Subject: Minutes for 57th Protection Sub-Committee Meeting.

57th Protection Sub-Committee Meeting (20th February, 2025)-MoM

**Minutes of
57th Meeting of Protection Sub-Committee (PSC) of
Northern Regional Power Committee**

SLD of 400/220kV Heerapura(RS) before the event

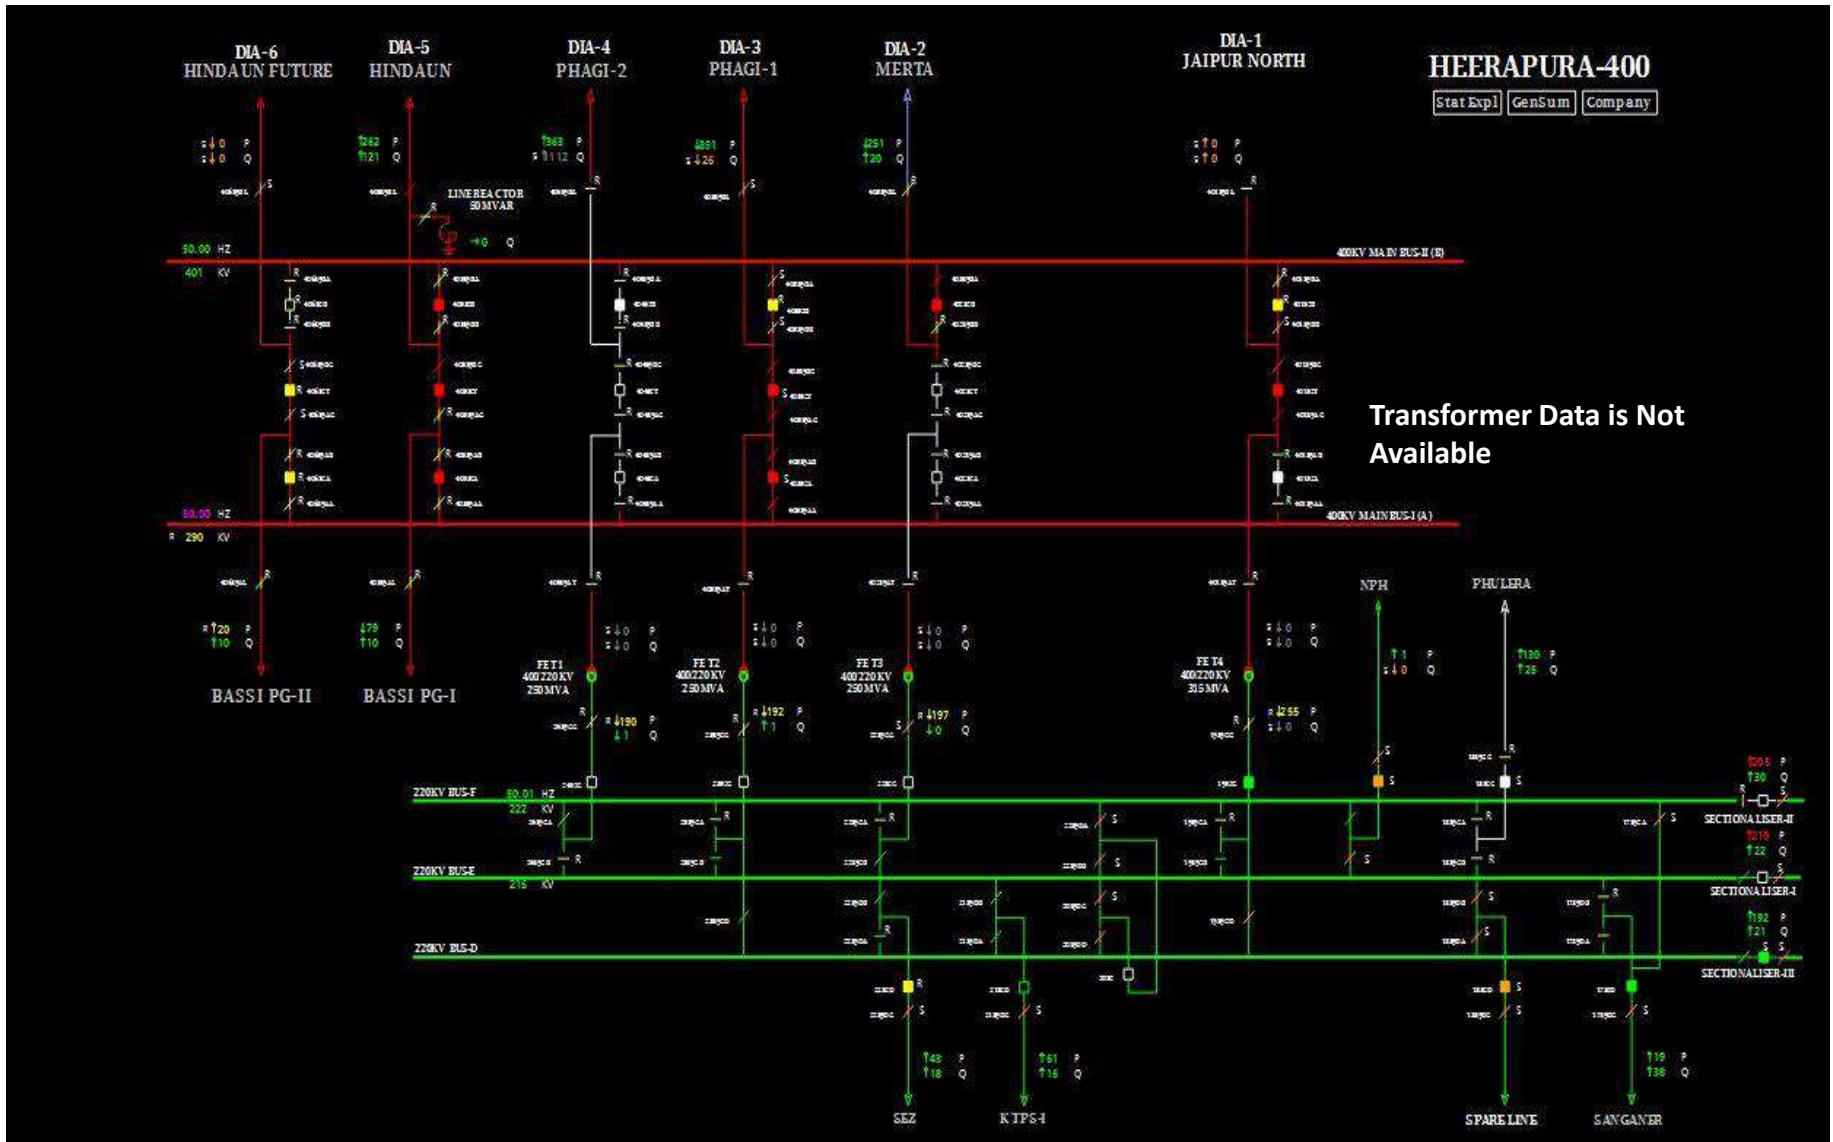
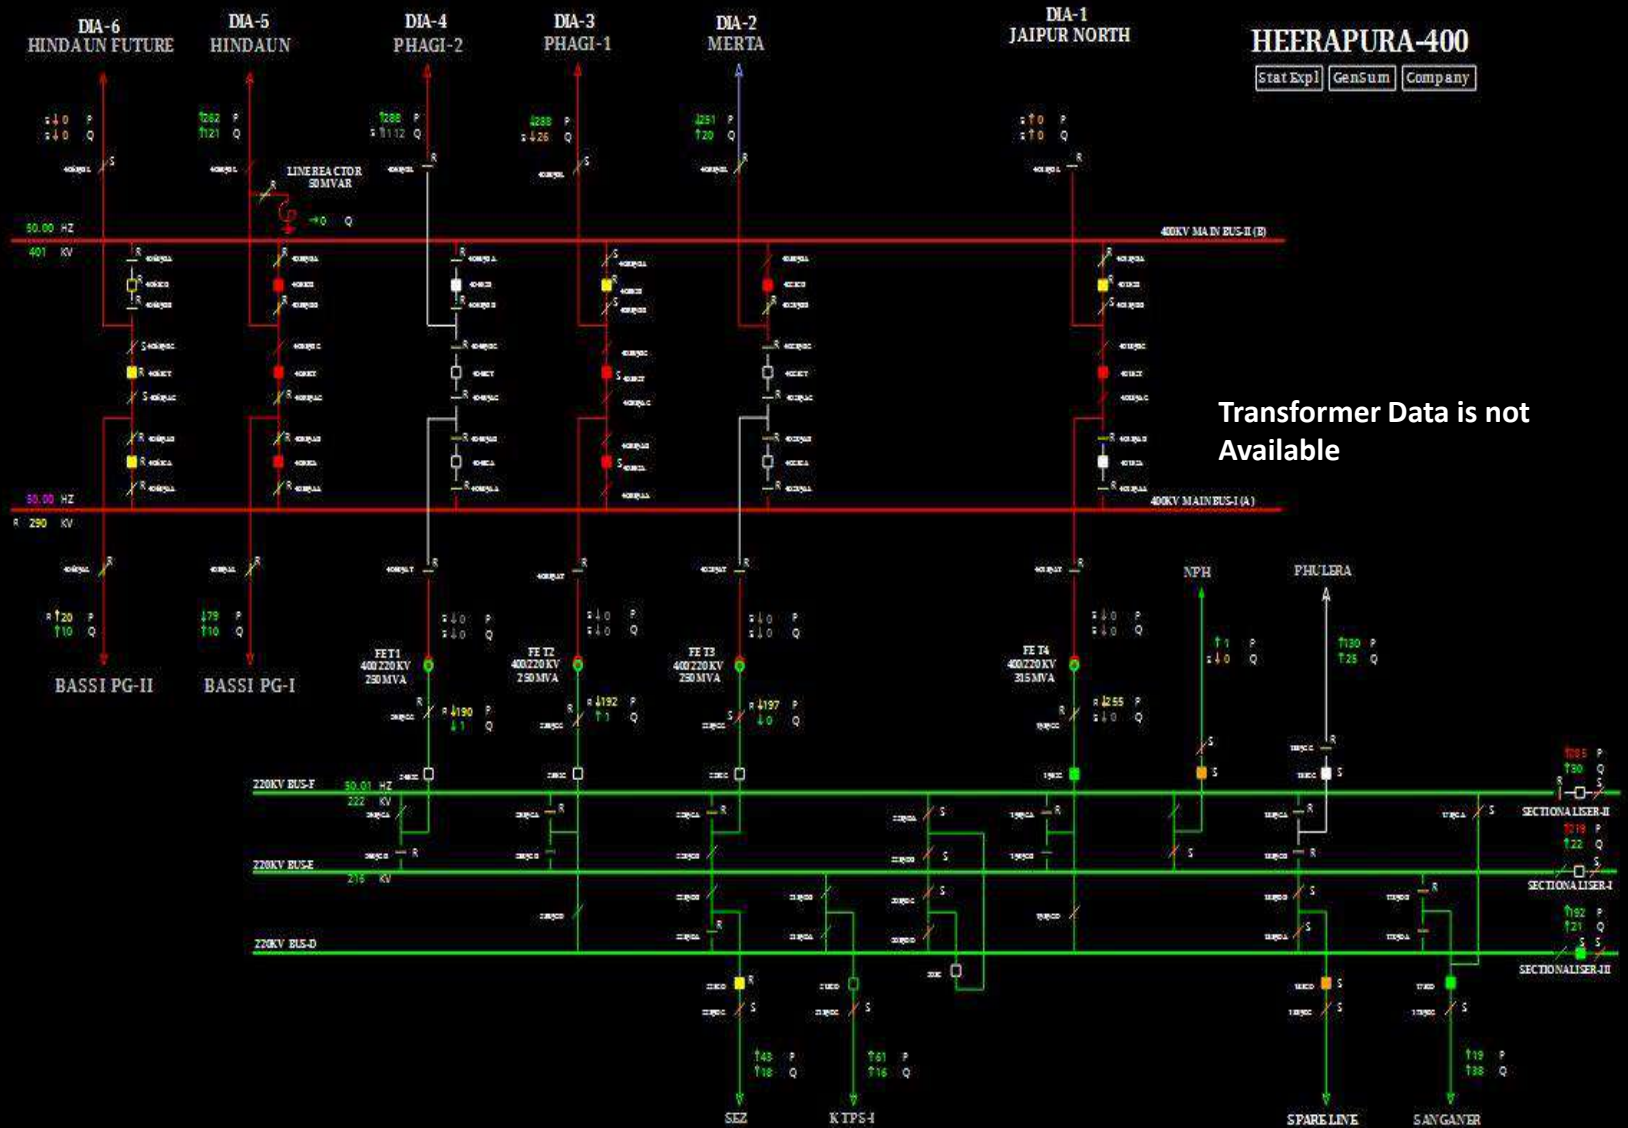
- i) Exact reason, nature and location of fault need to be shared.
- ii) The exact nature of protection operated during tripping of 400/220kV ICTs need to be shared.
- iii) Reason of delayed clearance of fault need to be shared.
- iv) DR/EL along with tripping report for each element need to be shared from both the ends.
- v) Remedial action taken report to be shared.
